OCONEE

PLANT NAME: Oconee
LICENSING STAGE: OL
DOCKET NUMBER: 50-269, 270, 287
RESPONSIBLE BRANCH: PWR #4
REQUESTED COMPLETION DATE: NA
APPLICANTS RESPONSE DATE NECESSARY FOR
NEXT ACTION PLANNED ON PROJECT: NA
REVIEW STATUS: Complete

The attached data completes our input to the ACRS Report
in the areas of population, nearby industries and
transportation routes.

DEMOCRATIZATION OF THE
NATION
CUMULATIVE POPULATION
DISTANCE (MILES)

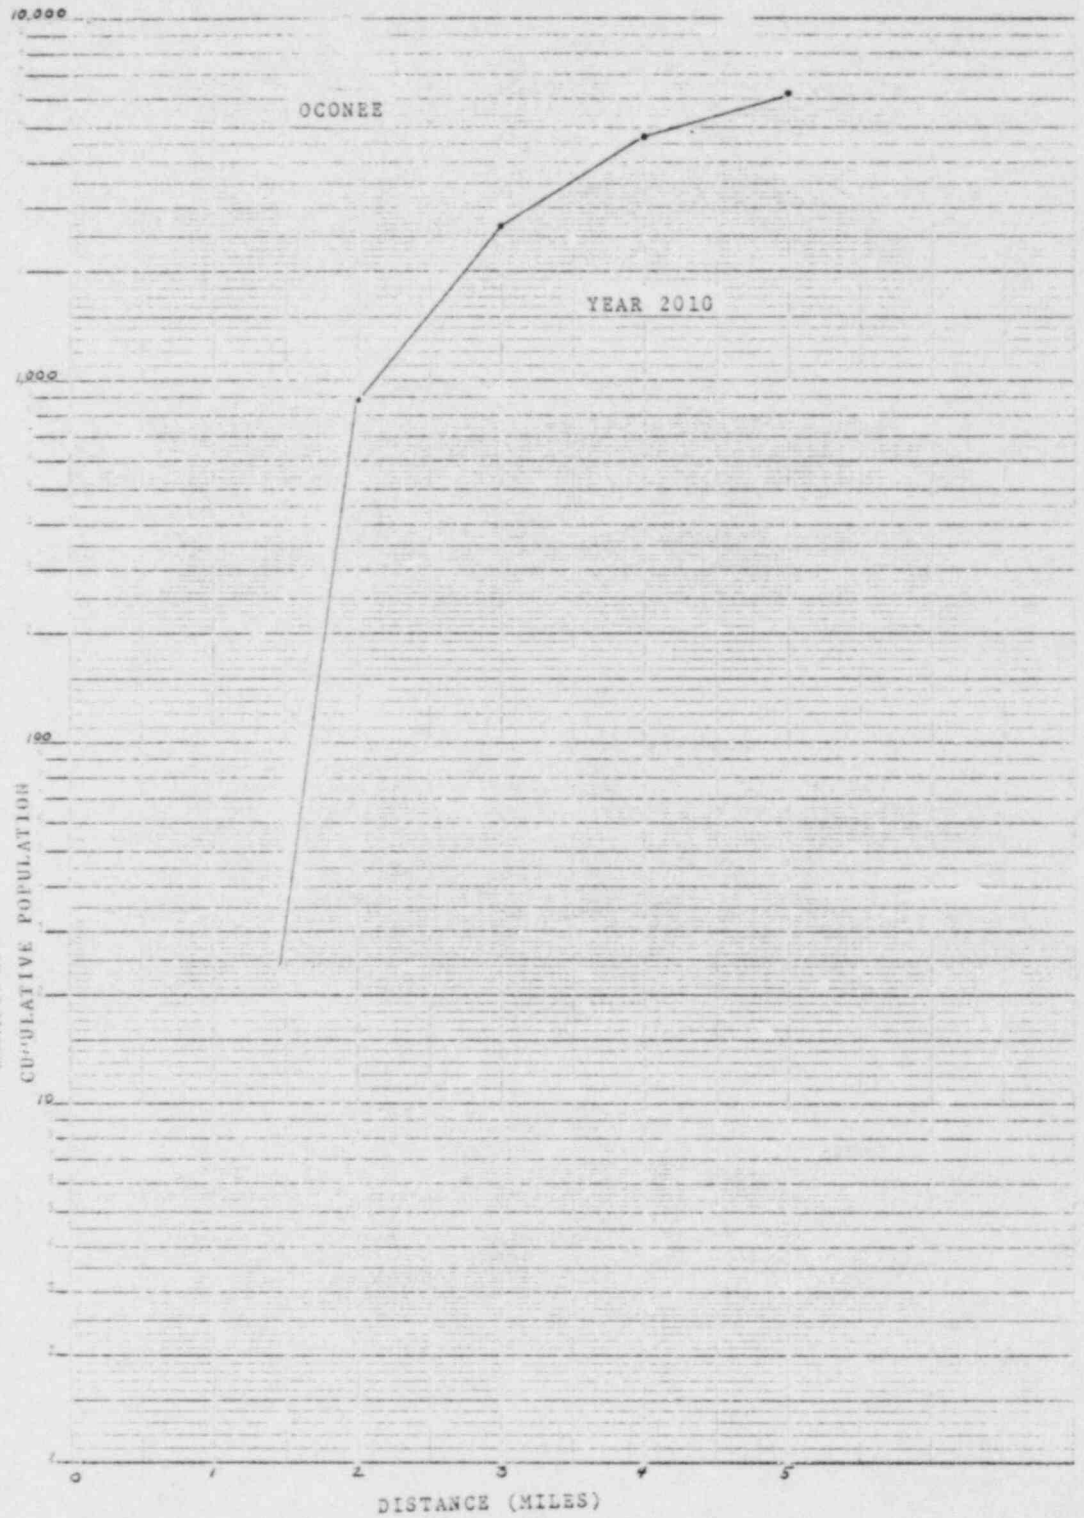
Figures 1 and 2 show the estimated Oconee year 2010 Population based on the 1970 census.
